UPCOTT WINDOW REPLACEMENT

Revised listed building consent drawing pack following Eastleigh Borough Council advice dated 17 September 2026

COUNCIL ADVICE RESPONSE

LISTED BUILDING CONSENT	COUNCIL ADVICE RESPONSE		
UPCOTT HOUSE, STATION HILL, BURSLEDON, SOUTHAMPTON SO31 8PQ	Drawing UP-LBC-010	Date 29 September 2026	Revision P06
Statutory list entry: Upcott, Station Road Grade II NHLE 1203865	Scale: as stated / NTS	Drawn: Dale Anderson	Sheet 2 of 13

REAR ELEVATION EXISTING AND PROPOSED

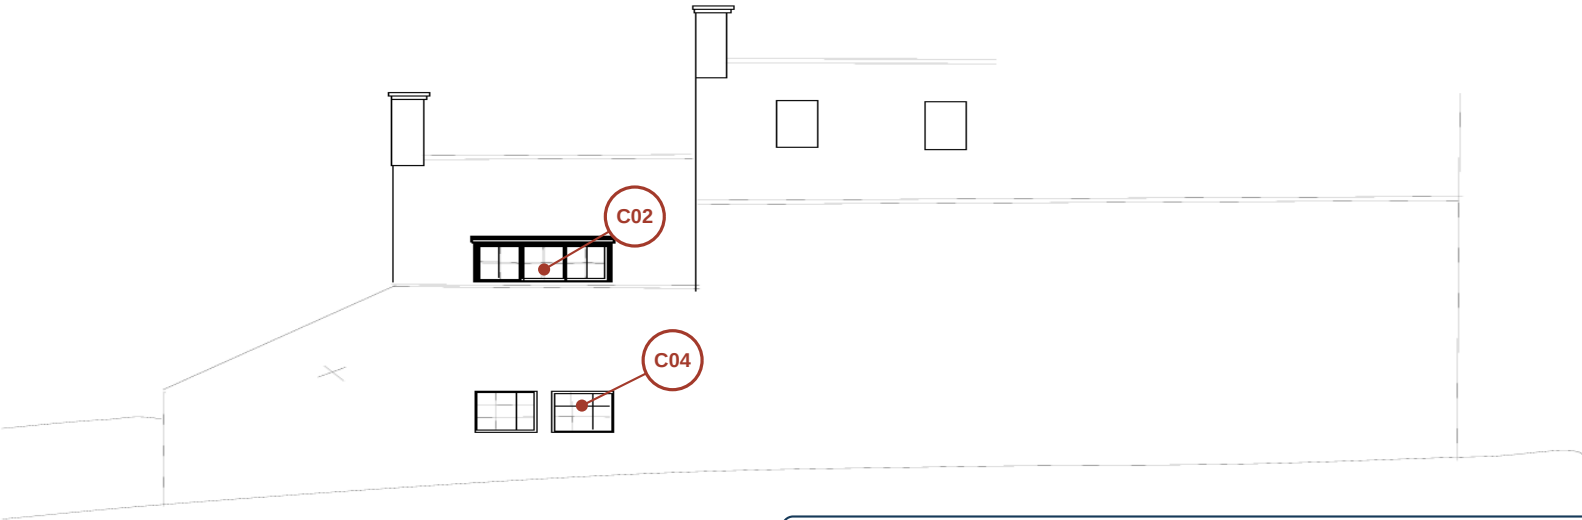
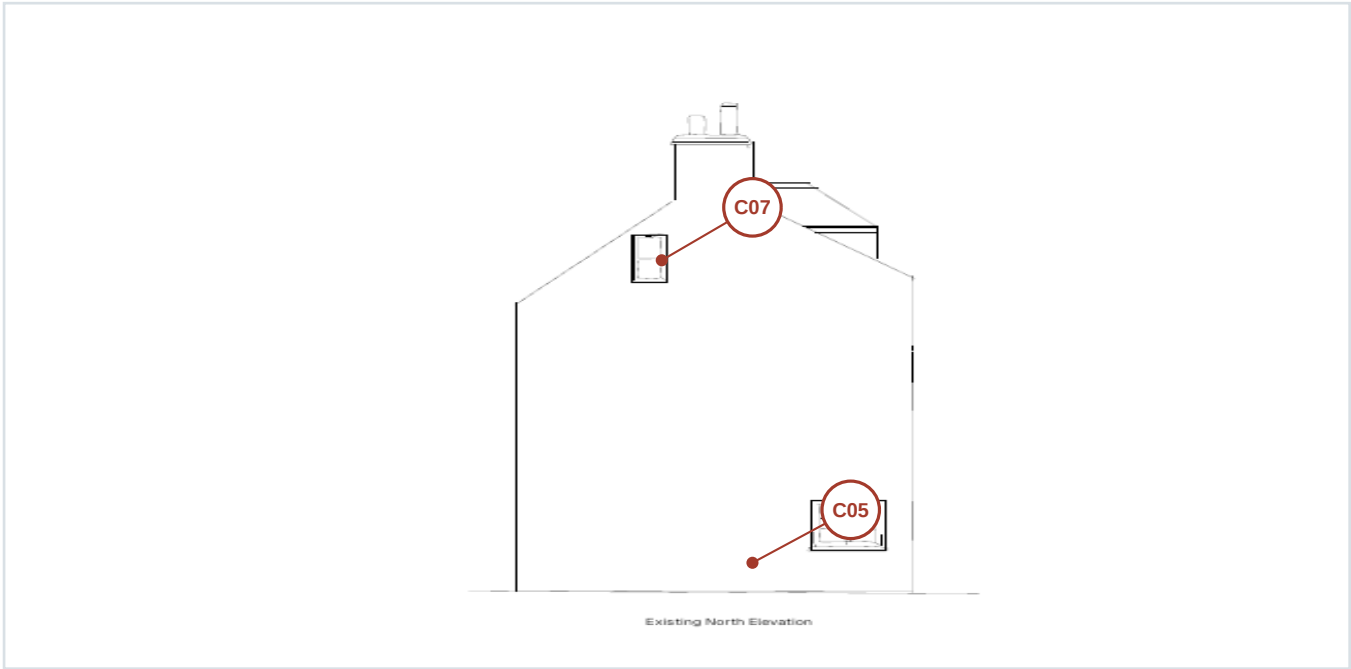
No.	Council observation	Revision made
1	Include optional staff bead	Included as a mandatory project option to S01-S05. See enlarged diagrammatic section and specification on UP-DT-200.
2	Add window numbers to elevations	Principal, rear and both side elevations are shown. Every proposed replacement is identified beside its opening, with a short leader where needed. The same references are used in the schedule and photographic survey.
3	Provide numbered photographs	The available external photographs are indexed on UP-PH-300 and cross-referenced to the numbered elevations. Individual close-up records are required before removal and retained with the works record.
4	Provide casement literature	The previous Logik Ovolo S references are removed. The casements are specified as REHAU Rio flush-fit units in accordance with the supplier quotation and REHAU Rio product literature.

C03 is not on this elevation; it is the middle bedroom window on Side Elevation B, as shown on drawing UP-EL-111.
